Public Works Project No. 89006007-23-034-C1

I-70 WB Centerville Welcome Center  
INDOT

**ADDENDUM NO. 1**

October 1, 2024

Drawing Number: TR/M6-1

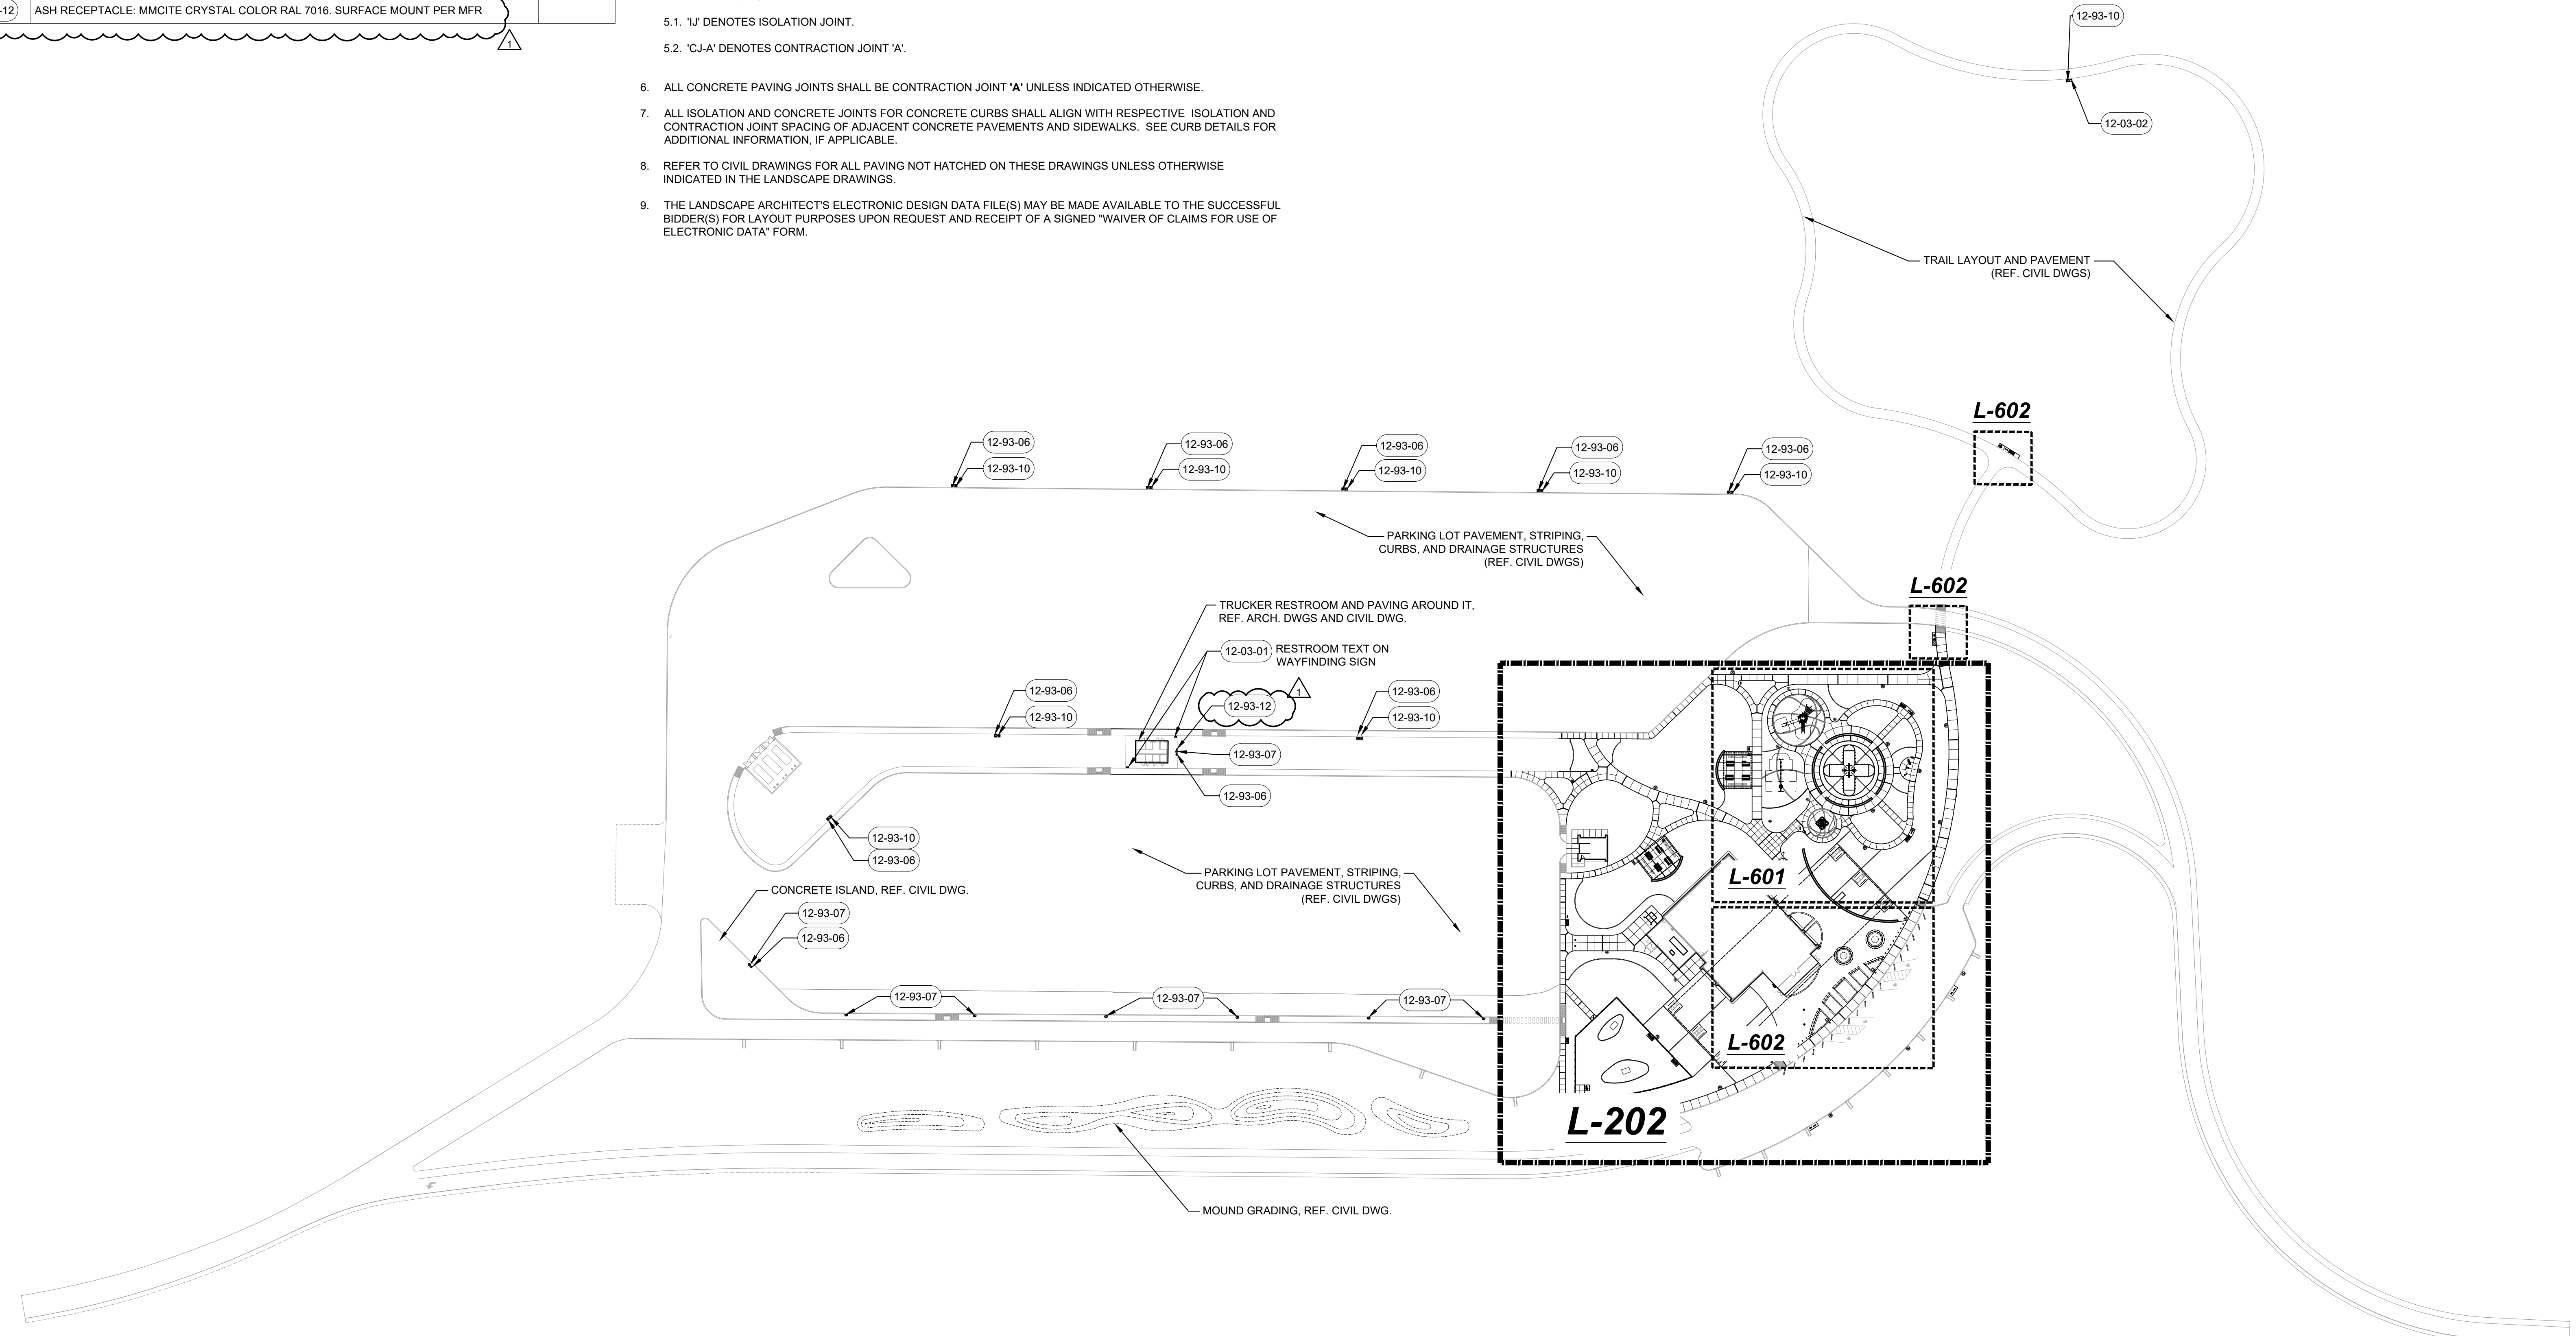
- Item No. 11-A1:**                    **Drawing Set #2, Sheet M6-1 MECHANICAL SCHEDULES**  
Replace:                                Replace Sheet M6-1 with attached Sheet M6-1  
Revise Packaged Geothermal Make Up Air Handler Schedule to identify changes related to R-454B refrigerant.

Project Number: 89006007-23-034-C1	
Requestion Number: -	
Account Number: -	
Designer:	Drawing Date: 08.30.24
Draftsman:	Drawing Scale:
IDAPW Approval:	
Client Approval:	
Reference Number:	
Building Reference:	
Drawing Number: L-201

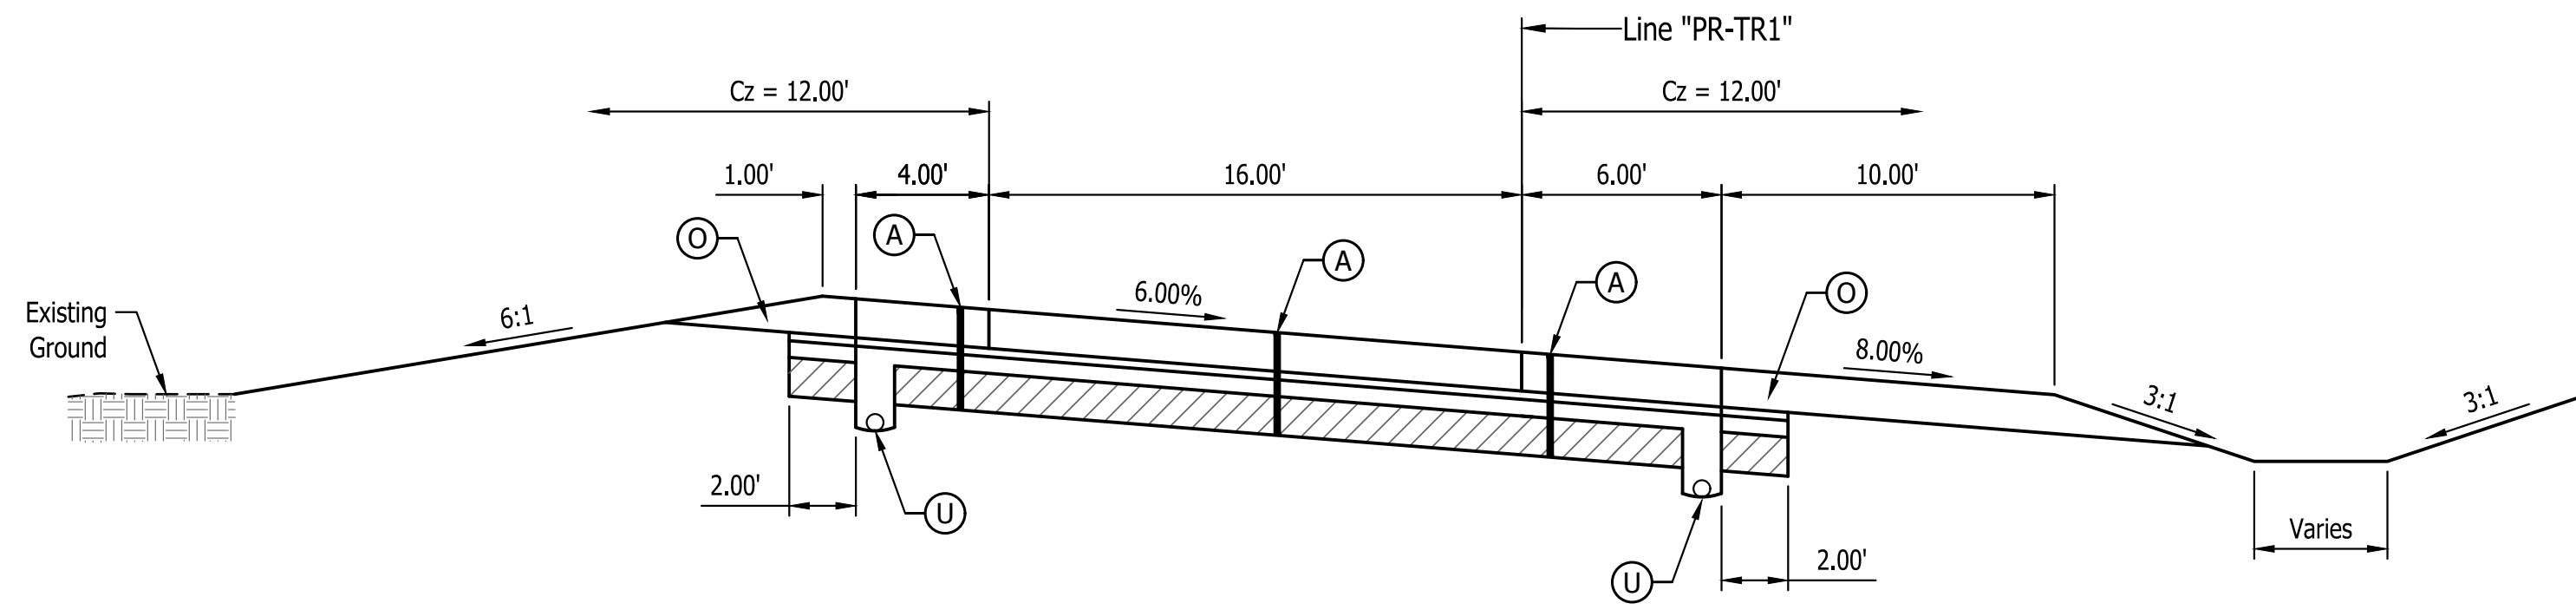
- Item No. 12-A1:**                    **Drawing Set #4, Sheet L-201**  
Replace:                                Replace Sheet L-201 with attached Sheet L-201  
Added ash receptacle by trucker restroom.

Typical Section  
Truck Exit Ramp - Line "PR-TR1"

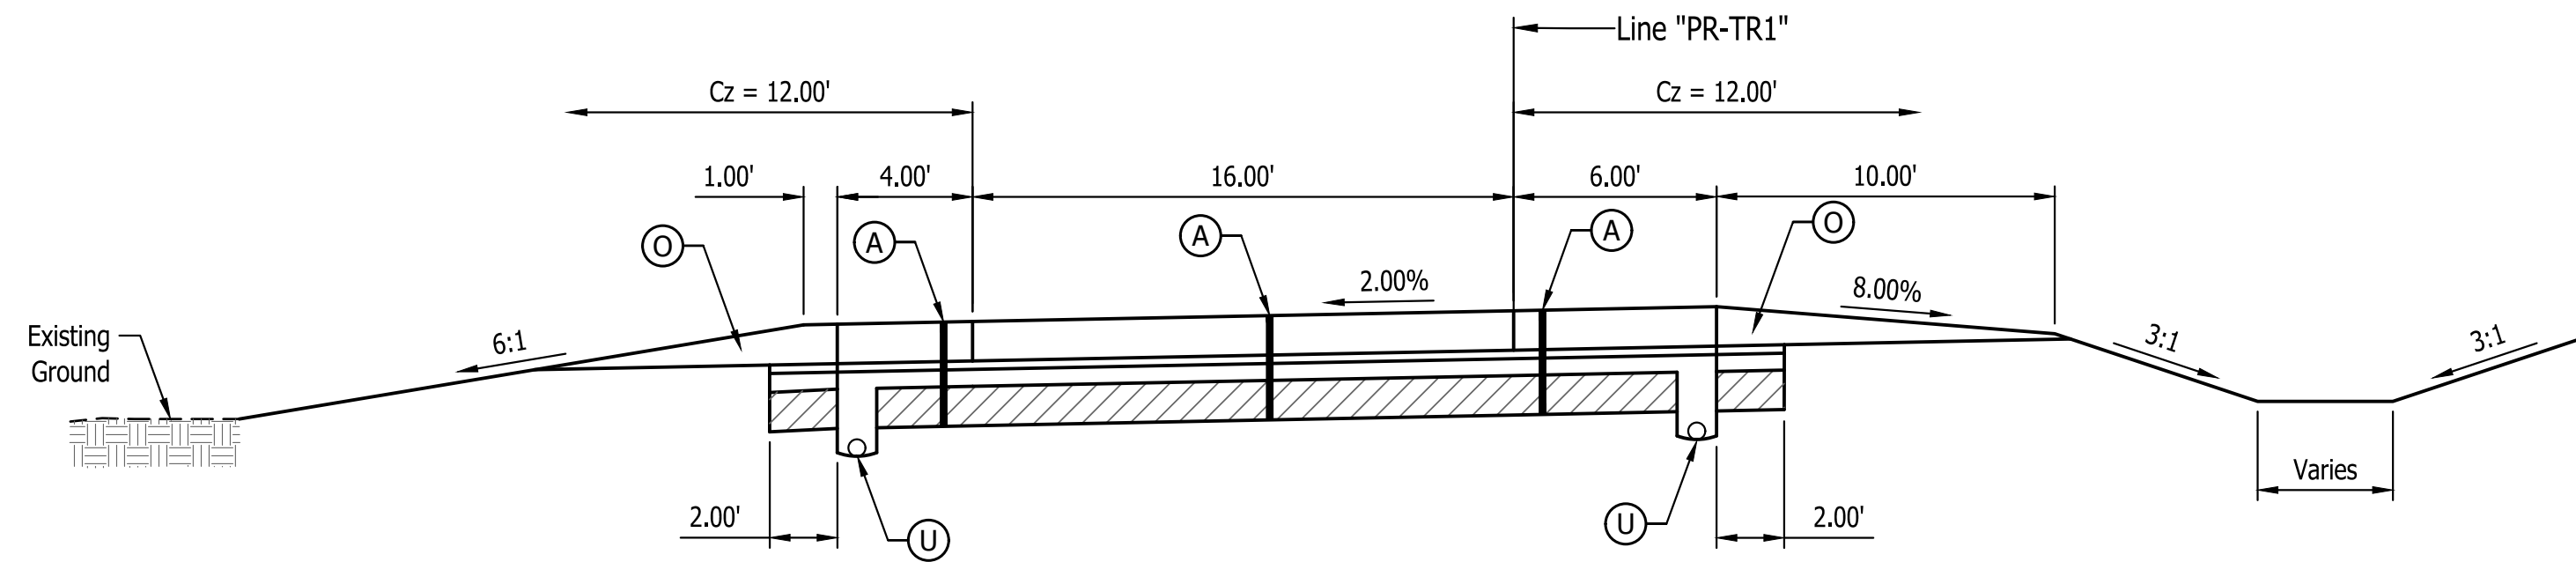
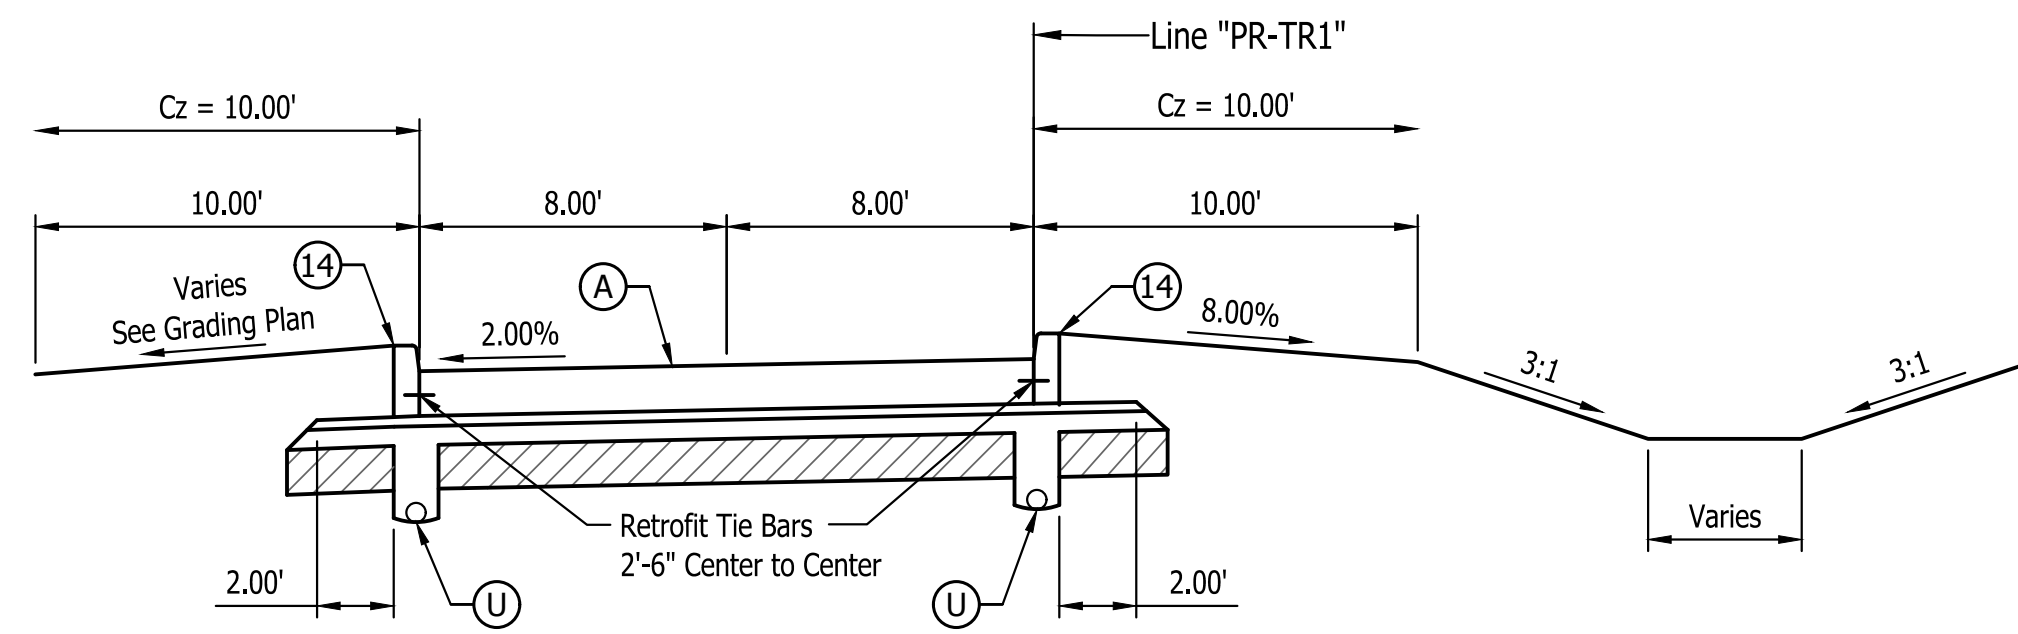
- Item No. 15-A1:**                    Drawing Set #5, Sheet C103  
Replace:                    Replace Sheet C103 with attached Sheet C103  
Revised Legend Items A and A1 per revised pavement design due to change in  
INDOT Binder Specifications.
